**ADDENDUM NUMBER 2**

Issued: November 29, 2012

**North Bay Water Reuse Program  
 Sonoma Valley County Sanitation District  
 Napa Salt Marsh Restoration Pipeline  
 (Carneros Reservoir to Huichica Unit)**

FROM: Sonoma Valley County Sanitation District  
 404 Aviation Boulevard  
 Santa Rosa, CA 95403-9019

DRAWING NUMBER: C-3

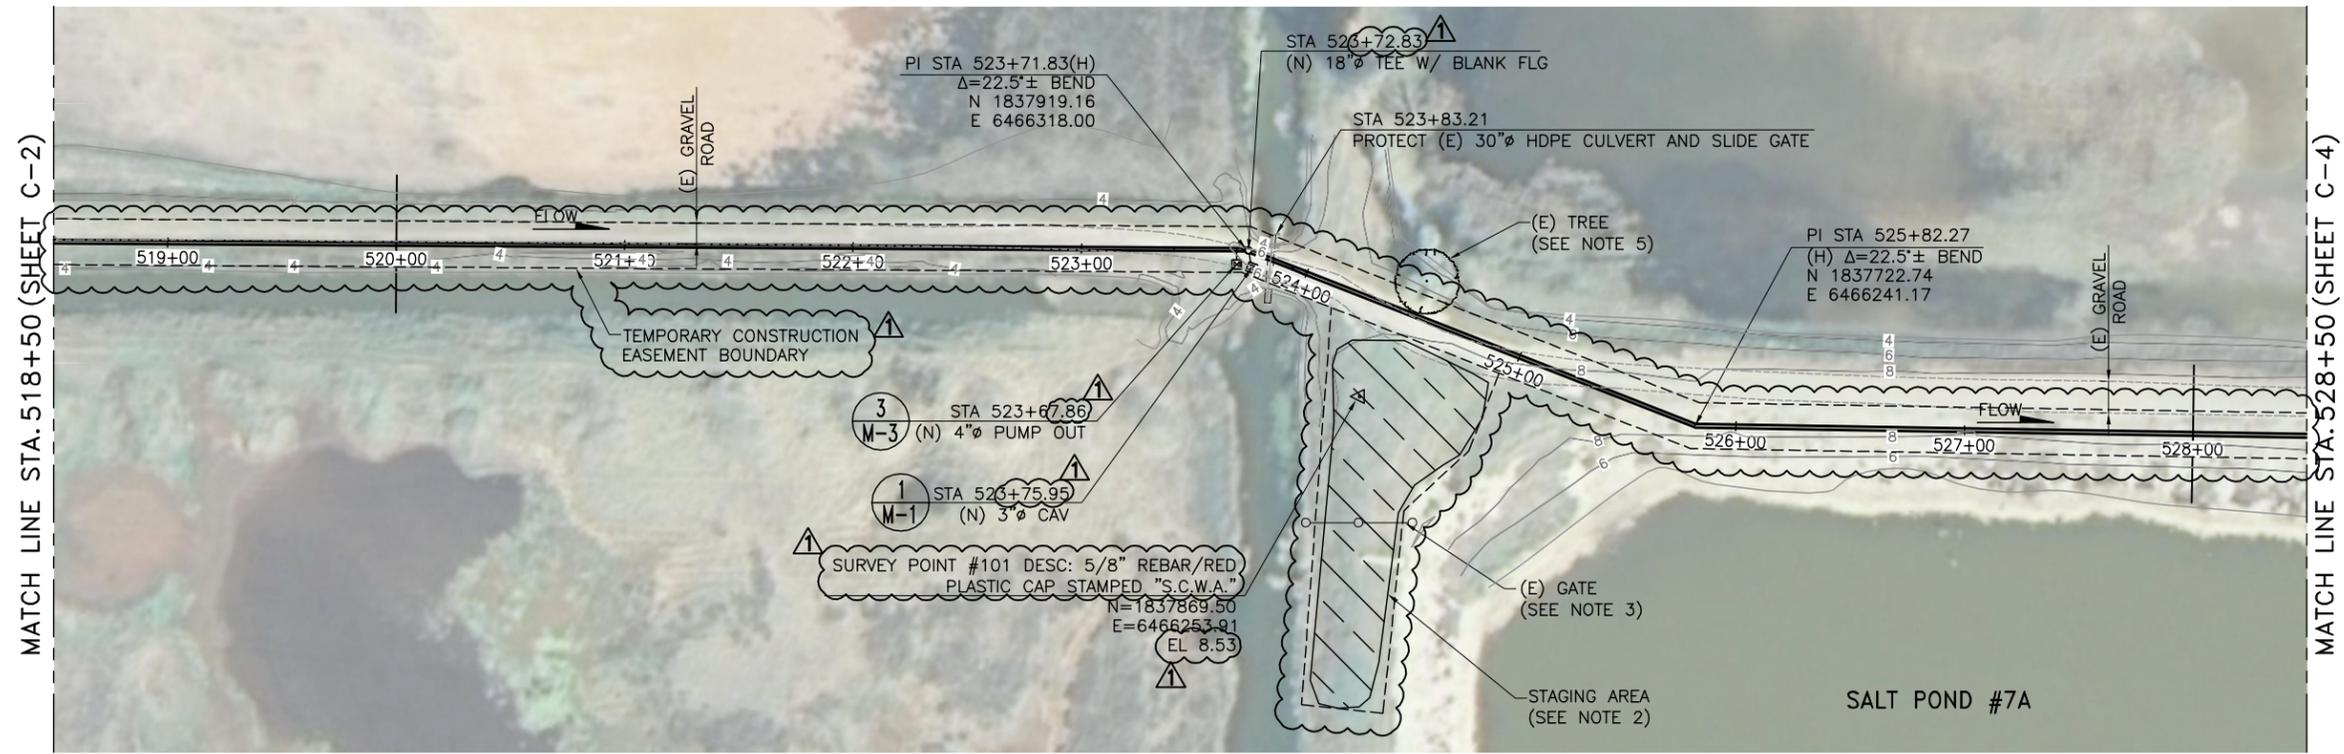
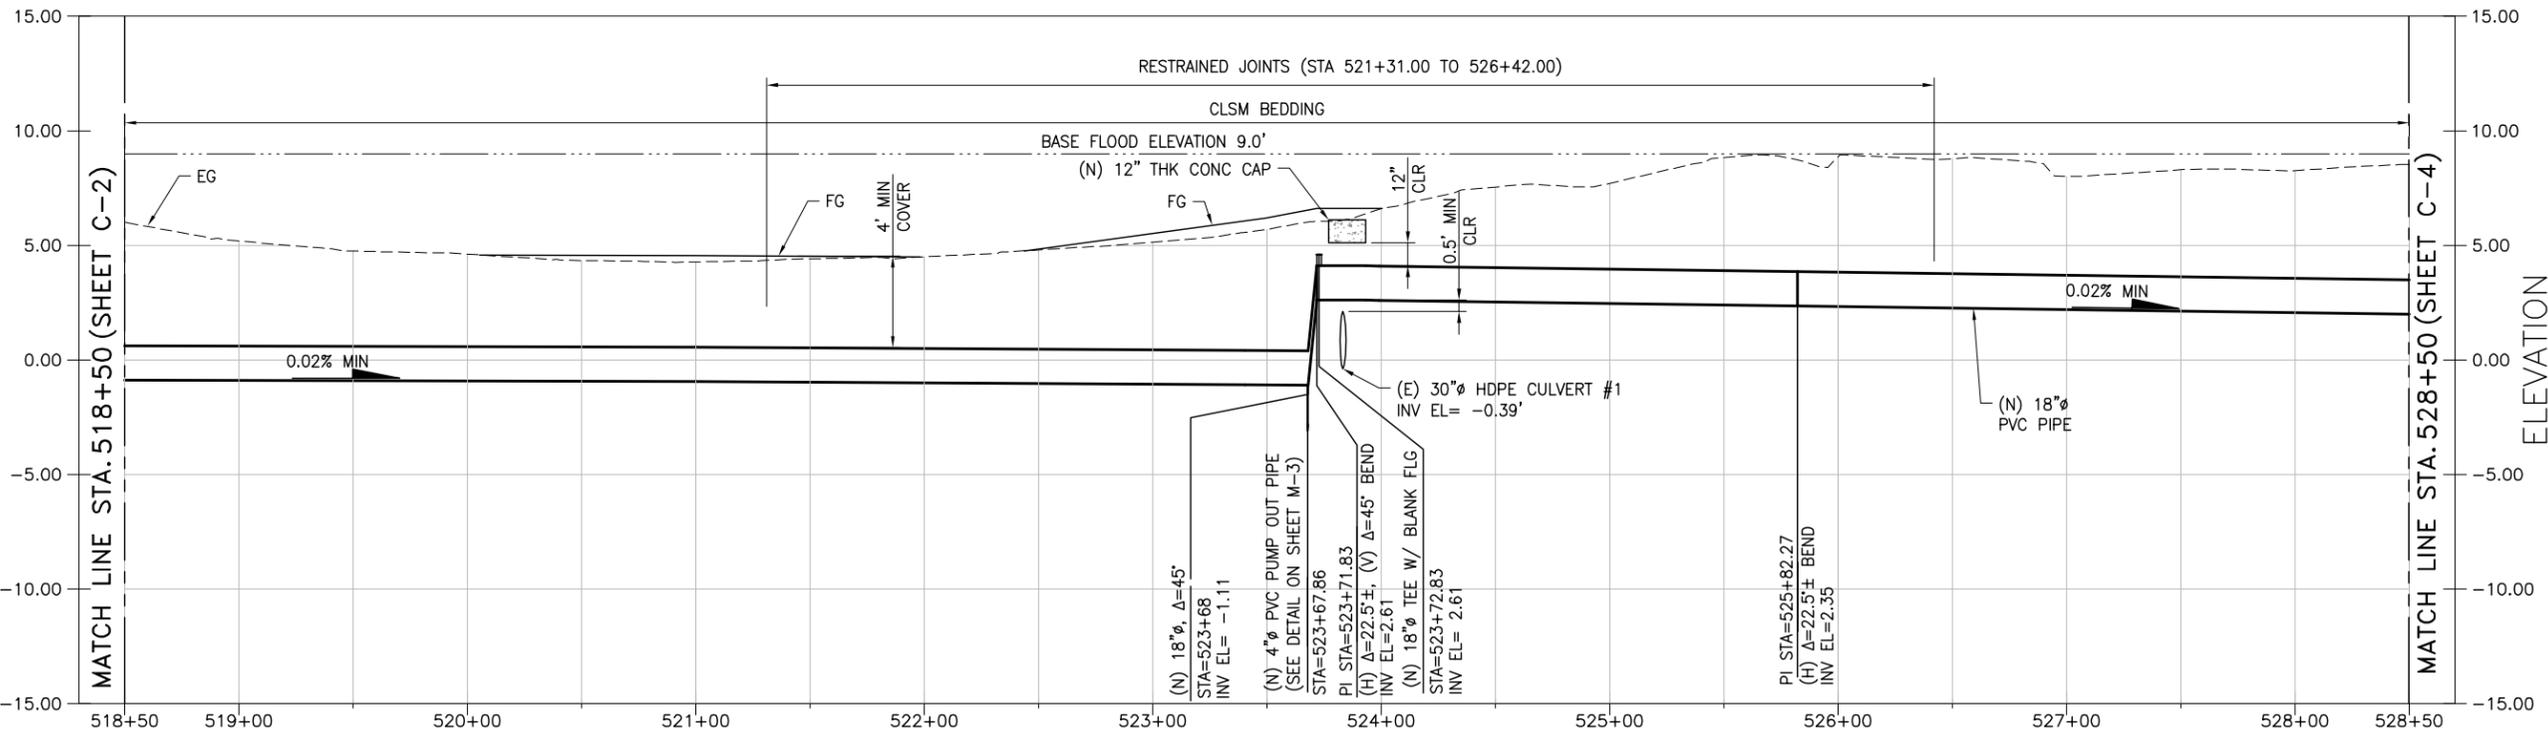
G. Delete Drawing No. C-3 and replace with Drawing No. C-3 attached and marked "11/26/12 Addendum 2"

FILE NAME: C-004.dwg	DRAWING NUMBER: C-4	SHEET 8 OF 19
CONTRACT NUMBER: -

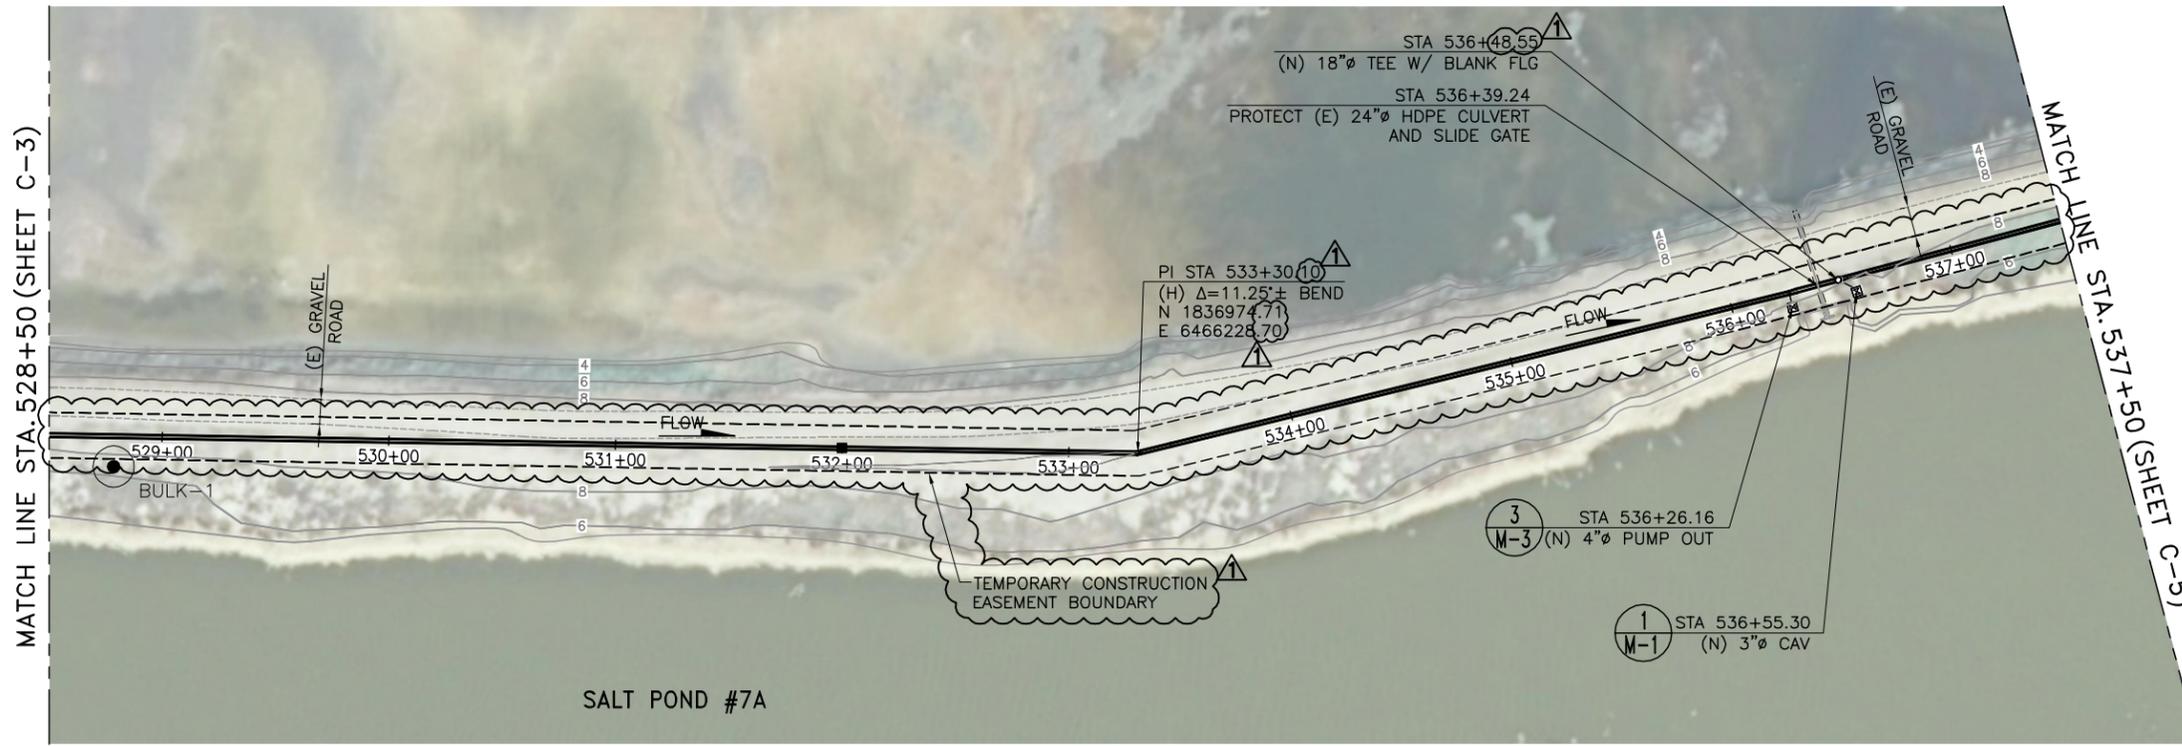
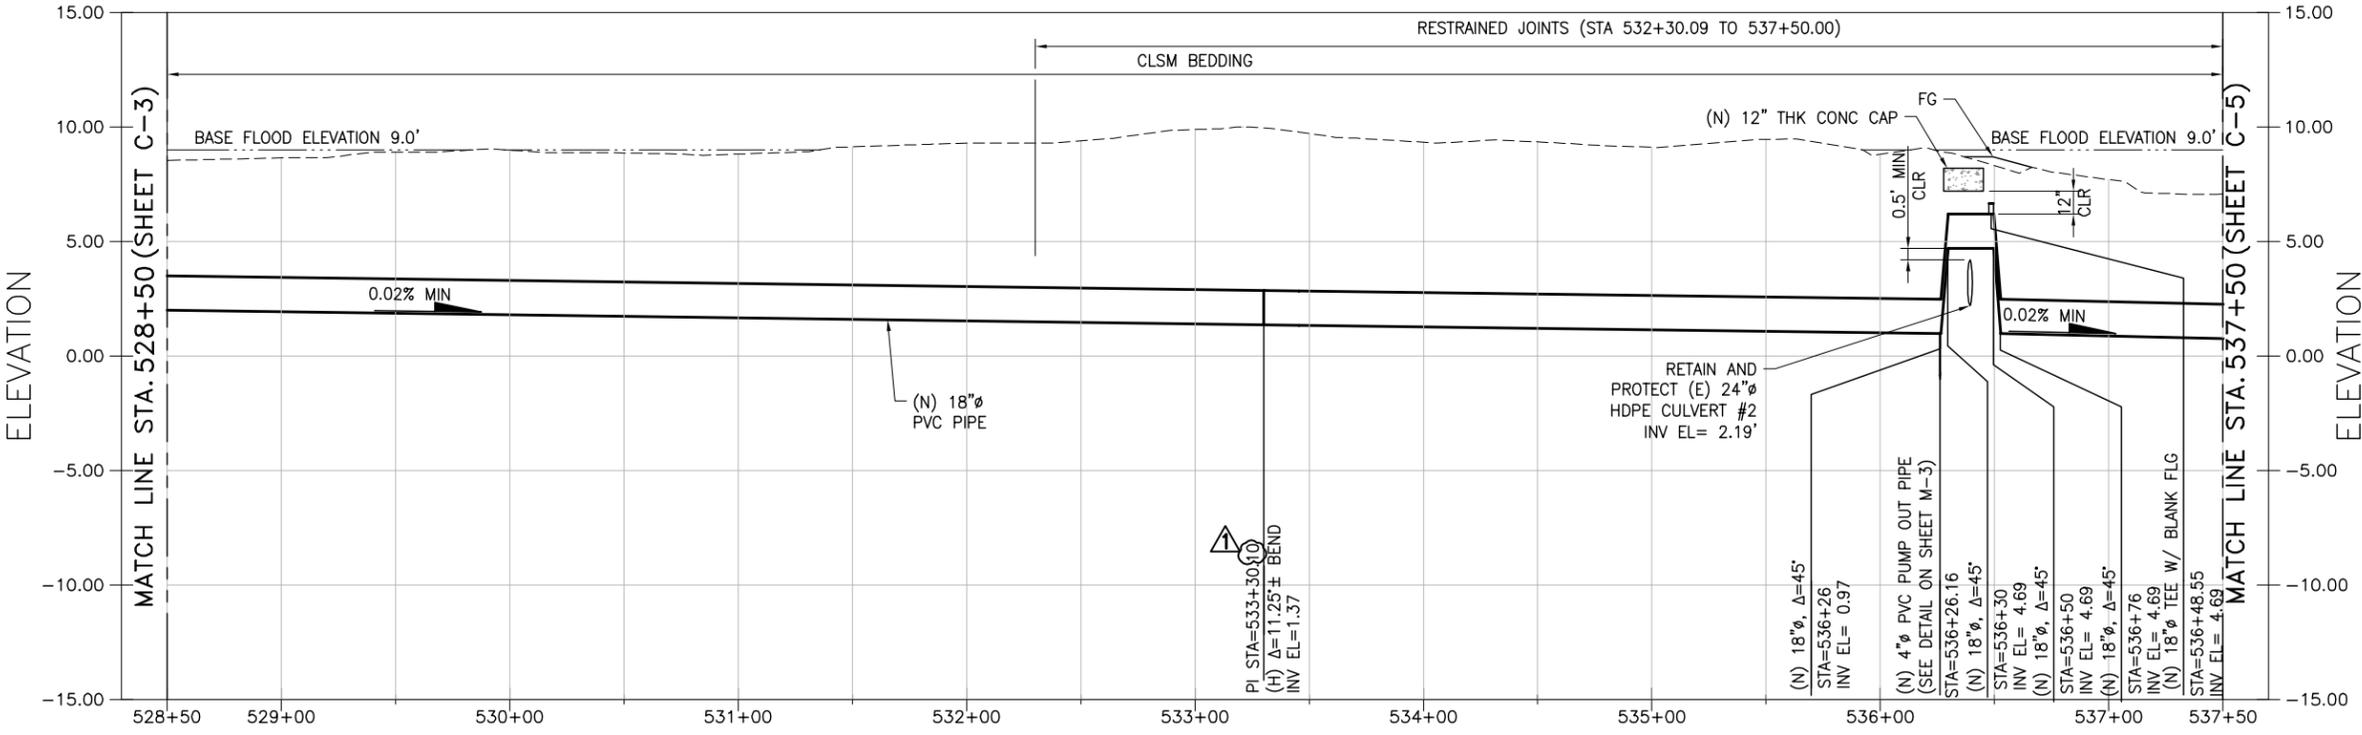
H. Delete Drawing No. C-4 and replace with Drawing No. C-4 attached and marked "11/26/12 Addendum 2"

DRAWING NUMBER: C-5

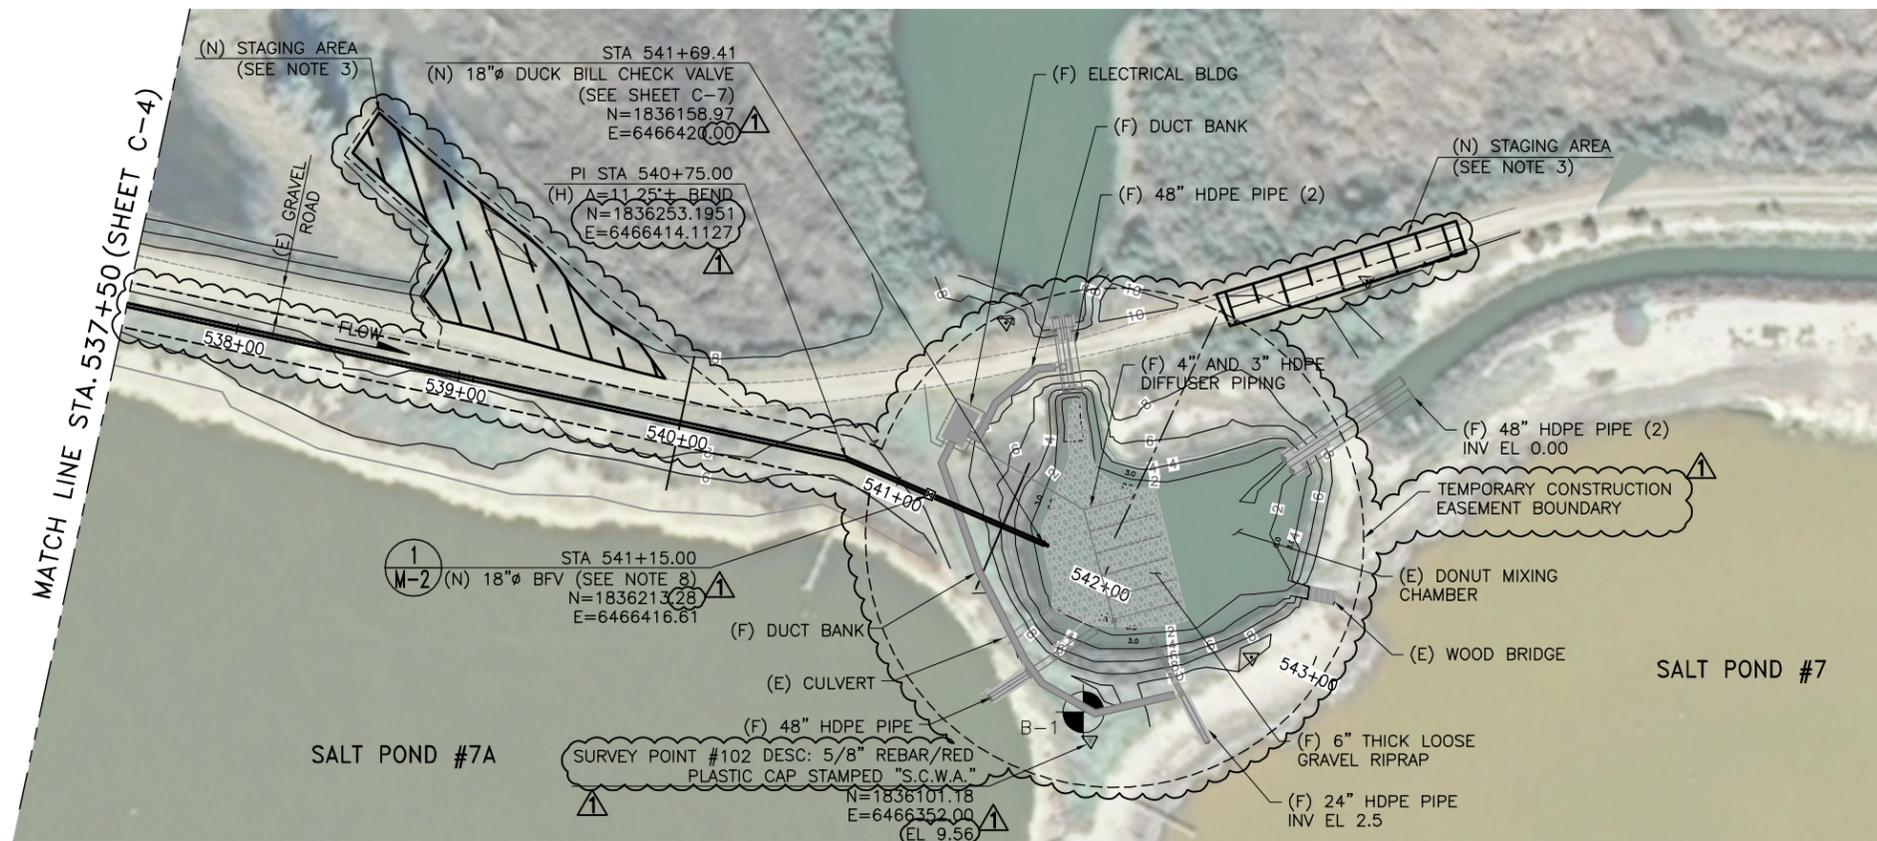
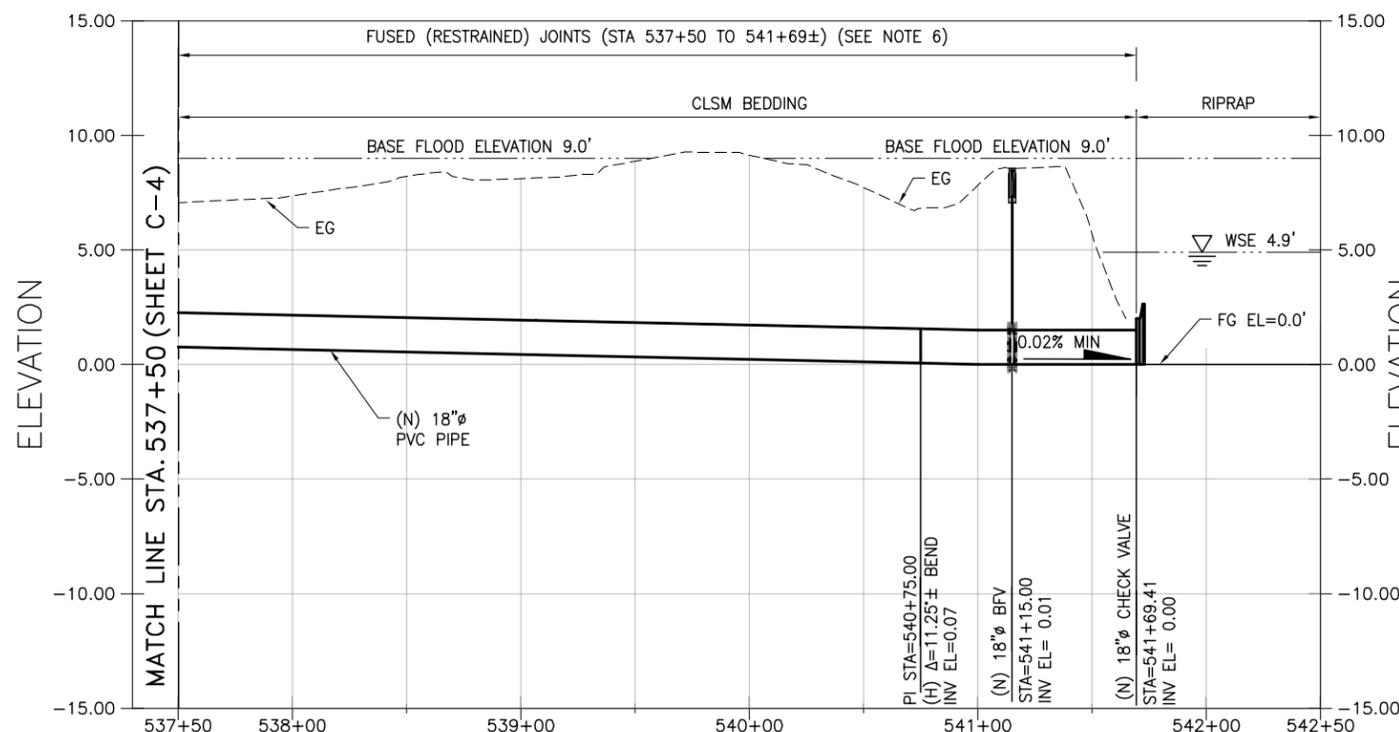
I. Delete Drawing No. C-5 and replace with Drawing No. C-5 attached and marked "11/26/12 Addendum 2"

NAPA SALT MARSH RESTORATION PIPELINE  
**COMBINATION AIR VALVE ASSEMBLY DETAILS**

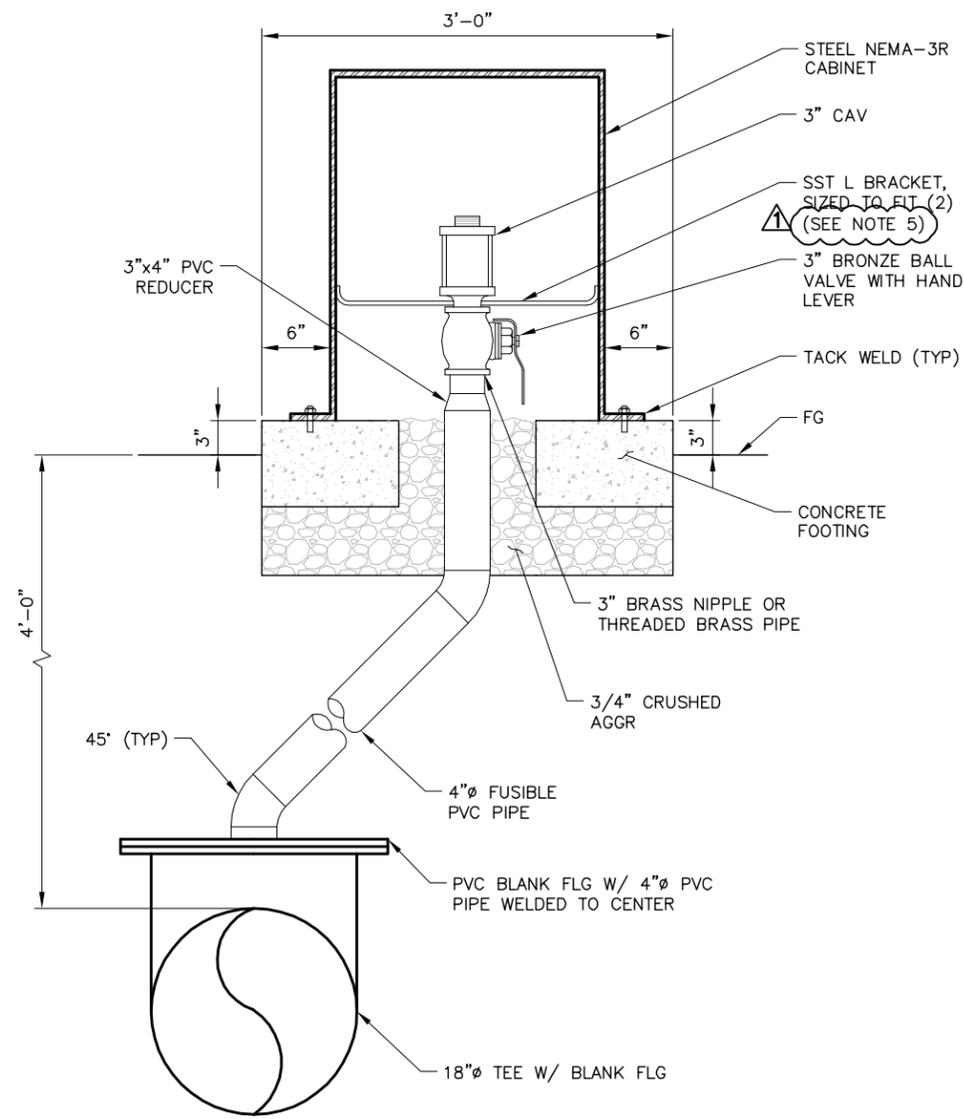
J. Delete Drawing No. M-1 and replace with Drawing No. M-1 attached and marked "11/27/12 Addendum 2"
